Access Compliance Report

Public Rights-of-Way

(Curb Ramps)

Intersection ID: 52550	Main Street: MEADOW_BOTTOM_RD	Cross Street: KRISTENS_MARE_DR	Location:	N
ADA ID: 6500941DD1C3	Ramp Type: Perpendicular Diagonal	Initial Pass/Fail: Fail	Overall Compliance: No	Severity Score: 12.5
Codes/Mitigation Info/Possible Solution		Field Measurements/Component Compliance

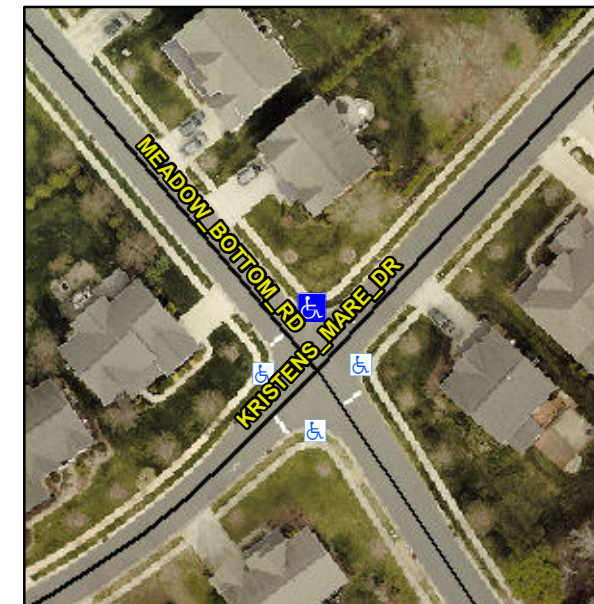
Not Found, R304.2.2

Compliance	Description	Data	Compliance	Description	Data
N/A	Ramp Length (in)	47.0	No	Ramp Slope (%)	9.4
Yes	Ramp Width (in)	48.0	Yes	Ramp XSlope (%)	0.7
N/A	Flare Type LT	N/A	N/A	Flare Type RT	N/A
N/A	Flare Slope LT (%)	N/A	N/A	Flare Slope RT (%)	N/A
N/A	Flare Traversable LT?	N/A	N/A	Flare Traversable RT?	N/A
N/A	Landing Length (in)	N/A	N/A	DWS Provided?	N/A
N/A	Landing Width (in)	N/A	N/A	DWS Contrast?	N/A
N/A	Landing Slope (%)	N/A	N/A	DWS Length (in)	N/A
N/A	Landing X Slope (%)	N/A	N/A	DWS Full Width?	N/A
N/A	Landing Curb? (Y/N)	N/A	N/A	DWS Offset (in)	N/A
N/A	Shared Landing?	N/A			
N/A	Gutter Ponding?	N/A	N/A	Gutter Slope (%)	N/A
N/A	Gutter Lip Ht (in)	N/A	N/A	Gutter X Slope (%)	N/A
N/A	Painted X Walk1?	No	N/A	Painted X Walk2?	No
	X Walk 1 Direction	To SW		X Walk 2 Direction	To SE
N/A	X Walk 1 Width (in)	N/A	N/A	X Walk 2 Width (in)	N/A
	X Walk 1 Slope (%)	2.2		X Walk 2 Slope (%)	0.8
	X Walk 1 X Slope (%)	2.1		X Walk 2 X Slope (%)	1.6

Remove & Replace Curb Ramp With Two New Directional Ramps or Equivalent.
